Dealer Service Information Service Bulletin No. 94-014

M3 Option Card FPGA Upgrade

DATE: 11/2/94
MODEL: Micro Lynx M3 Option Card
REVISION: A6
SERIAL NO: **Option Card Serial Number 465 through 545**
SOFTWARE: All
REQUIRED TOOLS:

Figure 3. FPGA IC Location

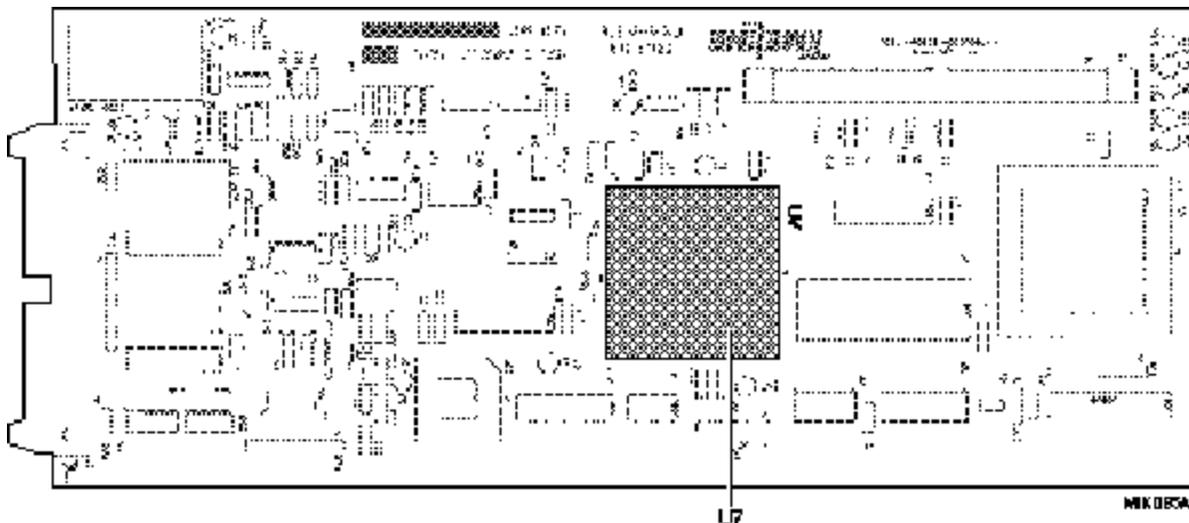
During power up, the Micro Lynx and/or the M3 Option Card may initialize incorrectly, resulting in nonrecognition of the M3 Option Card. The failure is characterized by no M3 LED or one or more LEDs flashing on the System Unit front panel. This will render the Micro Lynx inoperable. This is due to a problem with AT&T Programmable Gate Array (FPGA) PROMs. If your M3 Option Card is fitted with an AT&T FPGA, this IC **MUST** be replaced with a Xilinx FPGA (contact TimeLine for an RMA number). M3 Cards fitted with Xilinx FPGAs do not need this update.

5. On the M3 Option Card locate U7. (See Figure 3) If the letters “ATT” appear on the IC, contact TimeLine for an RMA number. If the Xilinx logo (X) appears on this IC, no replacement is necessary.

If the FPGA IC in U7 is a Xilinx IC, the failure is unrelated to this Service Bulletin, and must be diagnosed further.
